Attachment 3  
BYE-69319-66  
*cy1*

PERKIN-ELMER EVALUATION SUMMARY

PERKIN-ELMER EVALUATION SUMMARY

Attachment 3  
BYE-69319-66  
Category I, Figure I

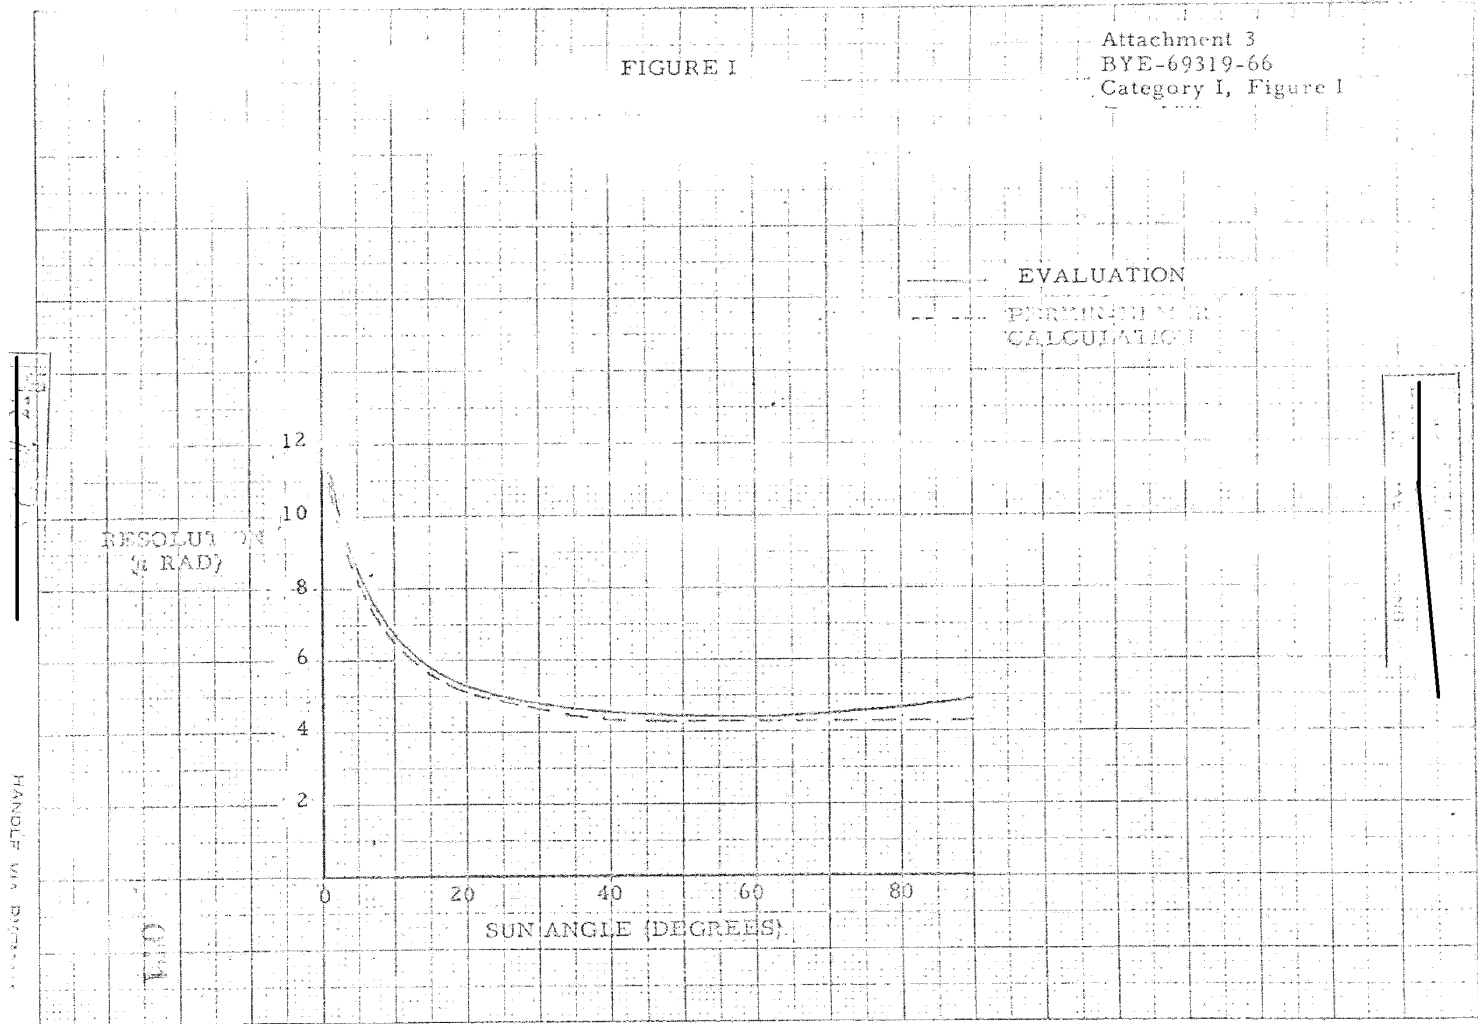
Performance Over the Design Envelope - After the contractor's performance estimates have been corrected for the errors and omissions in his error budget, the 2.7' ground resolution specified in the RFP leads to a perigee altitude selection of 92.5 nm. In order to meet the performance objectives of the RFP, however, the camera must operate over a range of altitude of 80-240 nm and a range of scene brightness from 200-750 ft. lamberts. Although the contractor does not present a complete discussion of camera performance over this entire operational spectrum, an analysis of the system has not uncovered any unusual performance variations. In particular, the smears resulting from residual image motion do not noticeably increase at the highest V/h corresponding to 80 nm perigee altitude.

Figures I, II, and III present a resolution performance summary. The curves labeled "Evaluation" reflect the revised error budgets of Tables I and II.
